Access Compliance Report

Public Rights-of-Way

Intersection ID: 50603	Main Street: RHODORA_RD	Cross Street: EMPRESS_CT	Location: SW
ADA ID: 8C03001CD899	Ramp Type: Perp	Initial Pass/Fail: Fail	Overall Compliance: No
Severity Score: 22.5			
Codes/Mitigation Info/Possible Solution		Field Measurements/Component Compliance

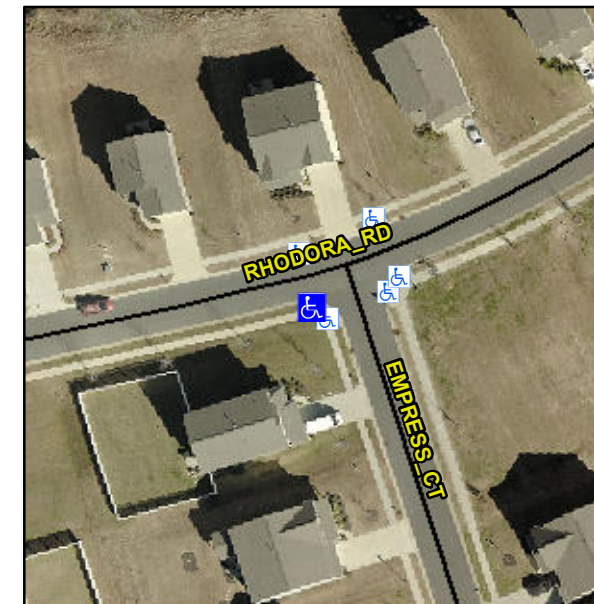
Not Found, R304.5.1, R304.2.2

Compliance	Description	Data	Compliance	Description	Data
N/A	Ramp Length (in)	49.5	No	Ramp Slope (%)	9.4
No	Ramp Width (in)	47.5	Yes	Ramp XSlope (%)	2.8
N/A	Flare Type LT	N/A	N/A	Flare Type RT	N/A
N/A	Flare Slope LT (%)	N/A	N/A	Flare Slope RT (%)	N/A
N/A	Flare Traversable LT?	N/A	N/A	Flare Traversable RT?	N/A
N/A	Landing Length (in)	N/A	N/A	DWS Provided?	N/A
N/A	Landing Width (in)	N/A	N/A	DWS Contrast?	N/A
N/A	Landing Slope (%)	N/A	N/A	DWS Length (in)	N/A
N/A	Landing X Slope (%)	N/A	N/A	DWS Full Width?	N/A
N/A	Landing Curb? (Y/N)	N/A	N/A	DWS Offset (in)	N/A
N/A	Shared Landing?	N/A			
N/A	Gutter Ponding?	N/A	N/A	Gutter Slope (%)	N/A
N/A	Gutter Lip Ht (in)	N/A	N/A	Gutter X Slope (%)	N/A
N/A	Painted X Walk1?	No	N/A	Painted X Walk2?	N/A
	X Walk 1 Direction	To N		X Walk 2 Direction	N/A
N/A	X Walk 1 Width (in)	N/A	N/A	X Walk 2 Width (in)	N/A
	X Walk 1 Slope (%)	2.2		X Walk 2 Slope (%)	N/A
	X Walk 1 X Slope (%)	2.8		X Walk 2 X Slope (%)	N/A

Remove & Replace Entire Ramp.
